**ADDENDUM 002**

**DATE:** August 30, 2019  
**ADDENDUM NUMBER:** 002  
**DG PROJECT NUMBER:** 3050  
**PROJECT NAME:** APS Coyote Willow Family School – Phase 2  
**PROJECT ADDRESS:** 7125 Irving Blvd NW, Albuquerque, NM 87114  
**ISSUED BY:** Wendy E.S. Caruso, AIA, Project Manager

**NOTICE:** *This addendum forms a part of the Contract Documents and modifies the Documents issued by The Hartman + Majewski Design Group and dated September 14, 2018. Acknowledge receipt of this Addendum in locations required on the Pricing Forms. Failure to do so may subject the Proposer to disqualification. All other provisions of the Contract Documents shall remain unchanged. This Addendum contains a total of Thirty One (31) 8 ½" x 11" pages and Six (6) 30" x 42" replacement sheets.*

#### **C101 SITE PAVING PLAN**

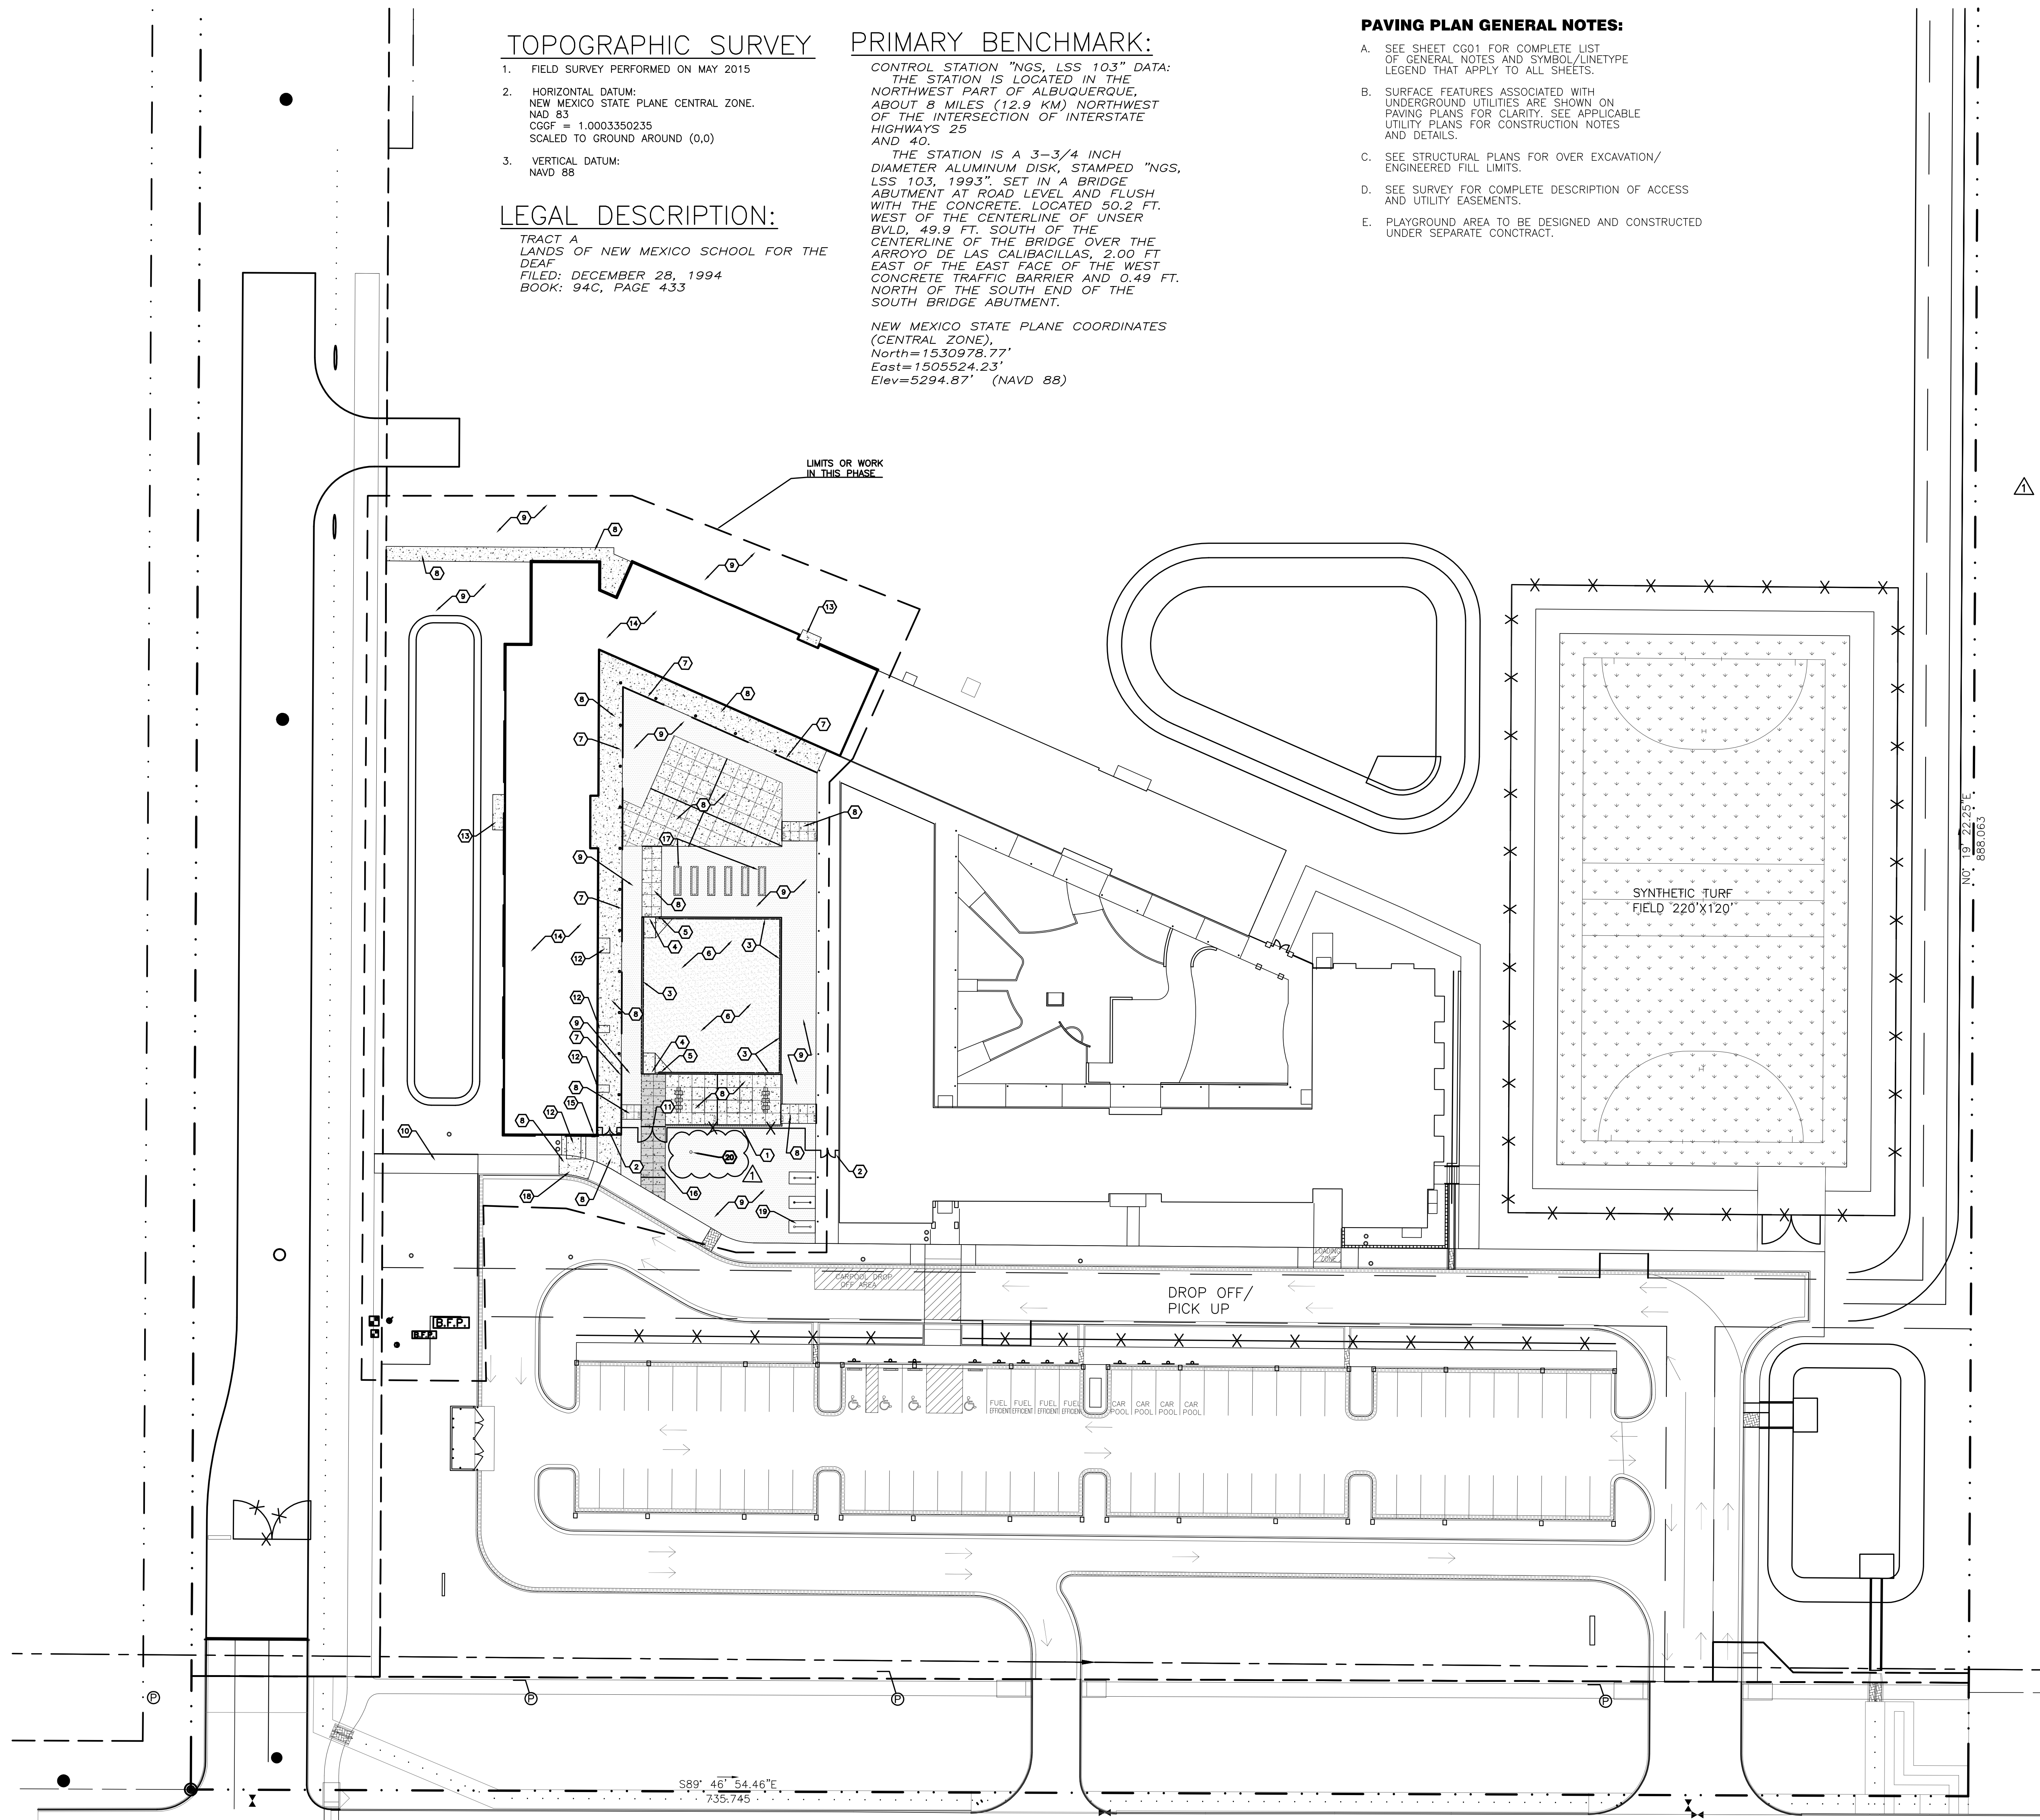
1. Add Flag Pole and Keyed Note #20.
2. Replace entire sheet C101.

19. BIKE RACK AND CONCRETE PAD TO MATCH EXISTING.
20. 40' FLAG POLE PER DETAIL B2/C501.

#### **S102 ROOF FRAMING PLAN**

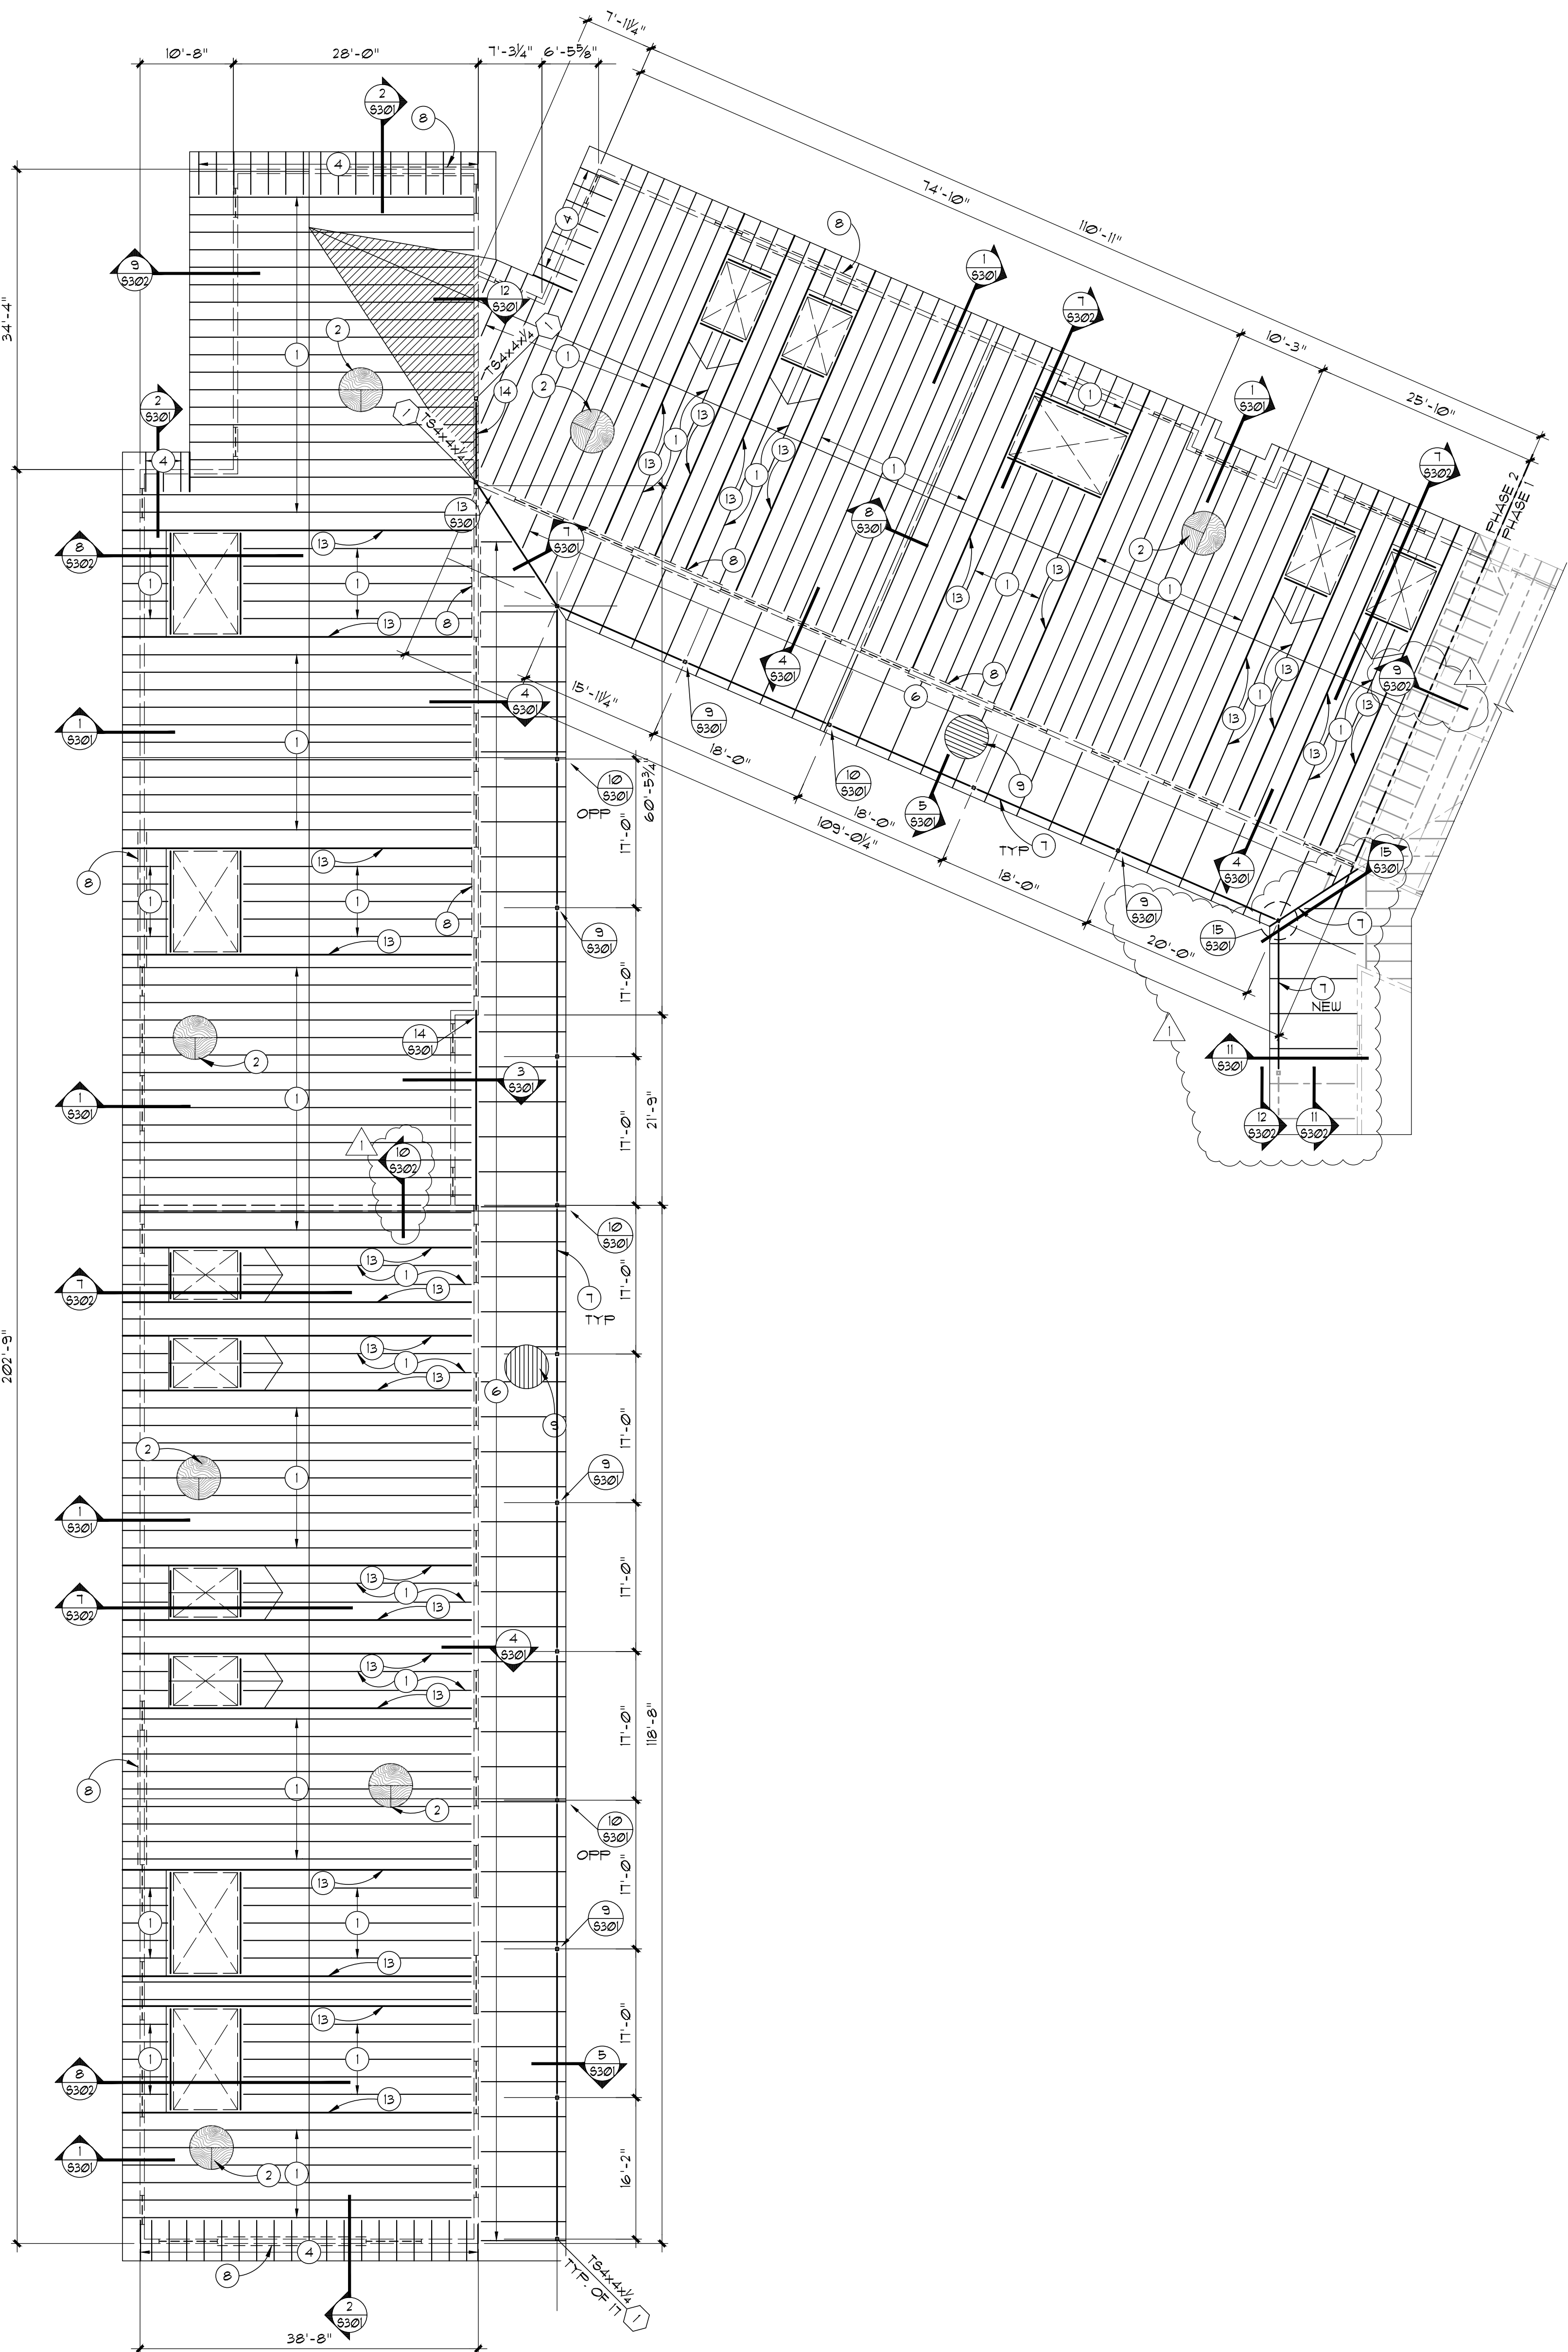
1. Detail 10/S302 has been added at the interior masonry wall to clarify the roof step.
2. Roof framing clarification has been added at the transition from the existing portal to the new addition.
